Reviewer #1

Summary: This paper uses repeat firn cores collected at four sites on the Juneau Ice Field, together with climate reanalysis and numerical firn modeling to investigate changing firn properties on the JIF and their impacts on runoff from the accumulation zone. Given the dearth of data on firn structure and firn hydrology on Alaskan glaciers, this paper provides a valuable first look at these questions.

Figure 2. Mean annual climate at each site (MLD, MG3, NWB1) in the accumulation zone from the product by Ing et al. (2024): mean annual skin temperature (a-c), cumulative annual snow-accumulation (d-f), and cumulative surface melt (g-i).

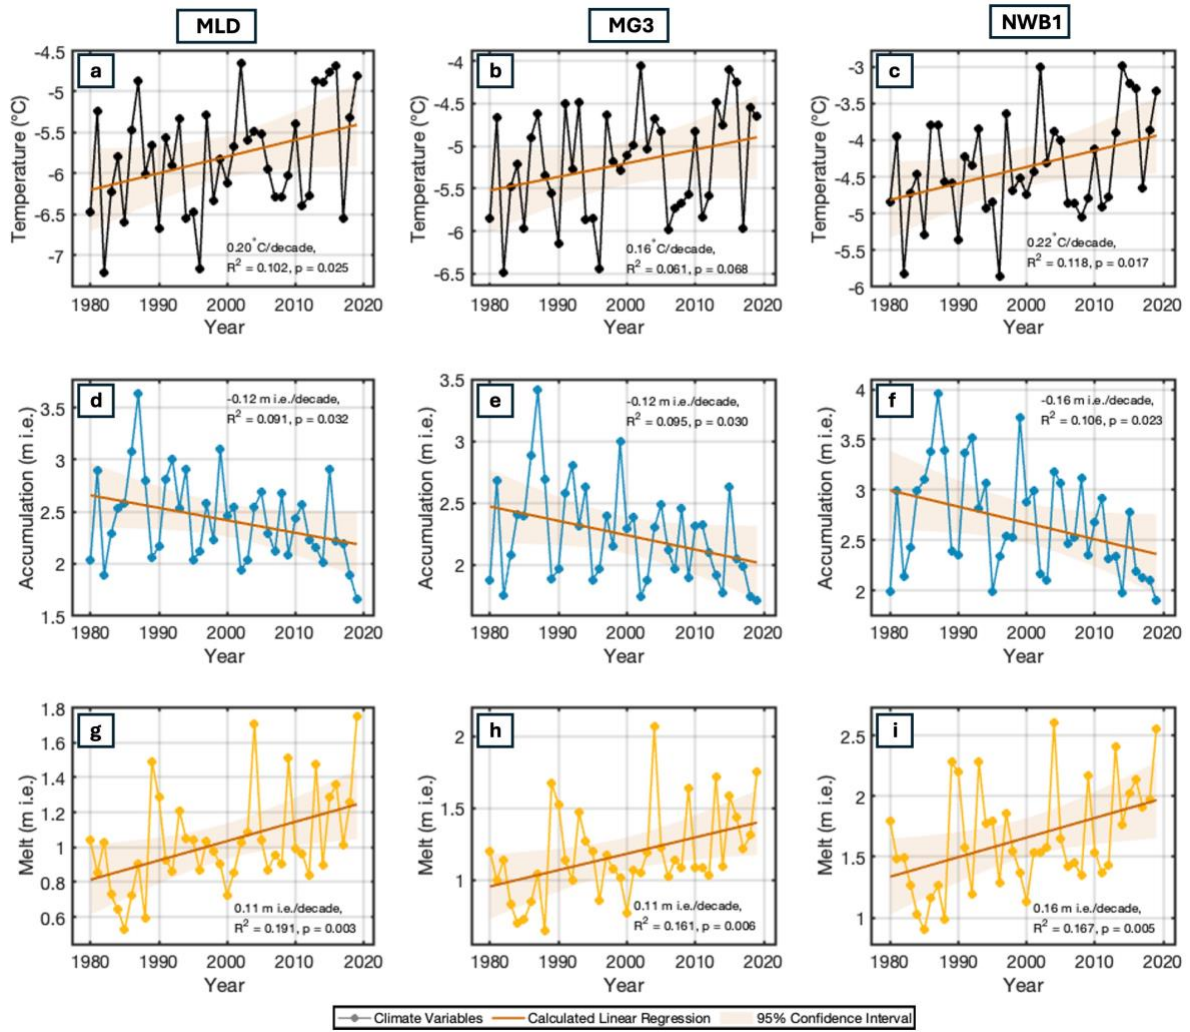
[4] For all analyses where you report rates of change, please give the p value and confidence intervals on the slope from linear regression results so the reader can evaluate how robust the relationship is.

Figure 2 - Color hard to distinguish from dotted/dashed lines, and dotted line is difficult to see. Also consider adding a legend for the locations

Thanks. For each linear least squares regression, we include the linear regression fit, the R squared value, the p value, and confidence intervals in the figures discussed in Section 3.1 “Changes in Climate” and Section 3.3 “Modeling Results” (see below). We also include these statistics on the figures and summarized in the Appendix Table A1 and A2 (not shown here).

Please note that the rain panels were moved to the appendix, since there were no significant trends. Please note we also omitted the melt volume panels in Figure 7 because melt is shown in Figure 2. We also separated each site into separate panels so readers can more easily see each dataset and the corresponding linear regression. While calculating these linear regressions, we also updated some variable values to ensure consistency across the manuscript.

Figure 7. Modeled cumulative annual refreeze in the firn (a-c), modeled cumulative annual runoff (d-f), and modeled annual depth-averaged liquid-water content (LWC) in the firn (g-i).

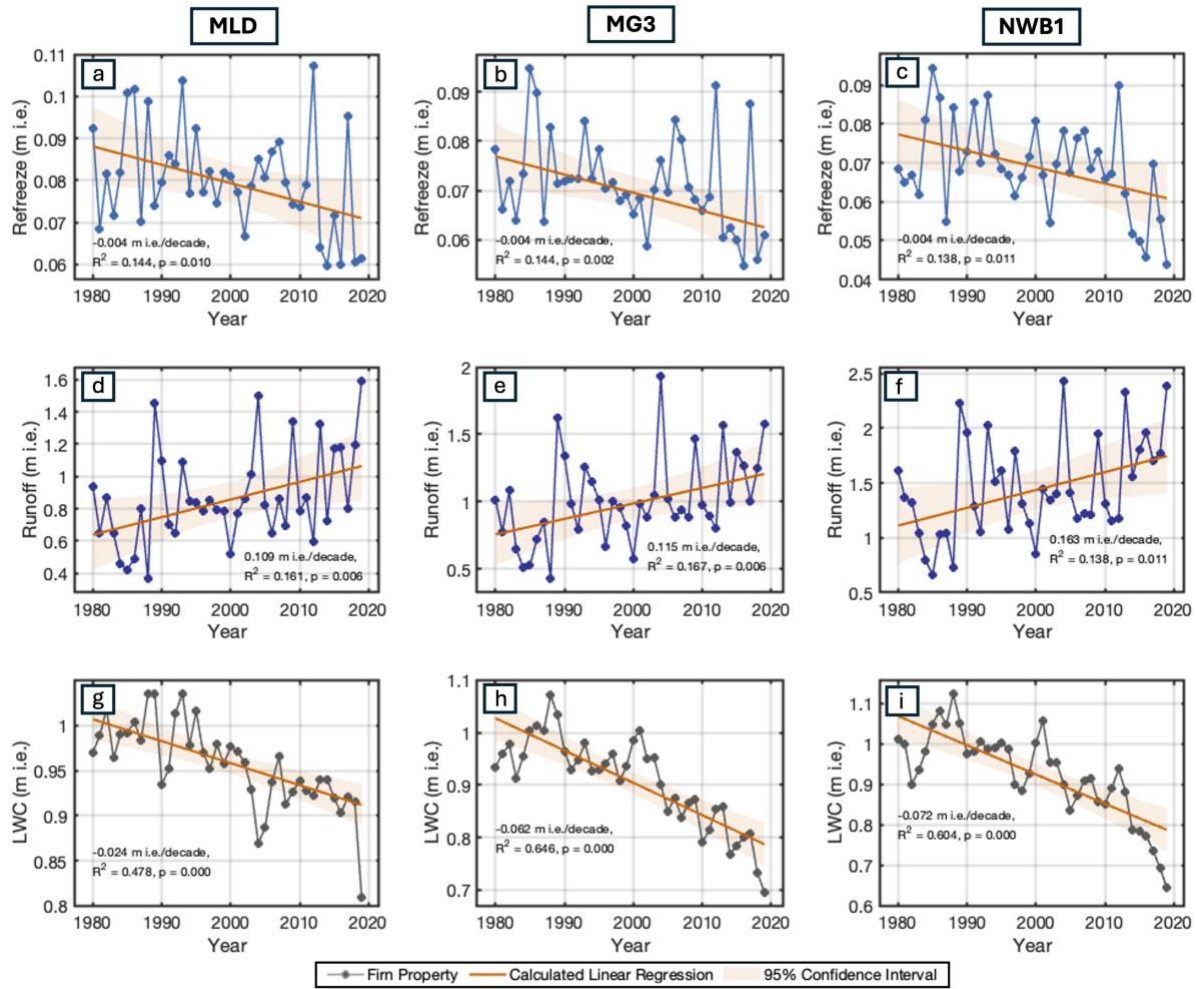
Lines 316 – 322: I don't totally understand the difference between "annual refreeze in the firn" and the "percent liquid water that is introduced into the firn that is refrozen".

We tried to clarify the latter in more detail on line 345 as: "the relation of annual melt/rain and refreeze in the firn" The annual refreeze in the firn is the total amount of refreeze in the firn, described in m i.e. (for a 1 m x 1 m section of firn column). The

relation of annual melt/ rain and refreeze in the firn is a percent to describe how much meltwater and rain water is refrozen (vs runoff vs stored), expressed as a percent.
